INDESIT company

Model type:
AVXF129FR

Commercial code:
F034408

n1040381: Drain pump with bayonet-style filter - front Loading Brembate

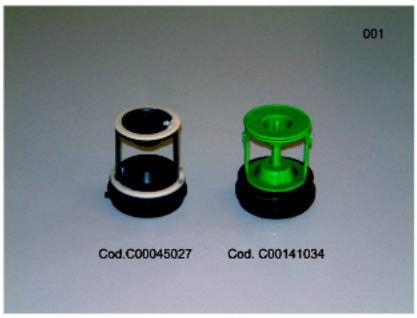
From serial no. 50720.0001 a new drain pump with bayonet-style filter has been installed on all front loading washing machines manufactured in Brembate.

New parts:
C00119307 - Drain pump
C00141034 - Pump filter kit

Premodification parts:
C00092264 - Drain pump
C00045027 - Pump filter kit

The new parts can be used instead of premodification ones.
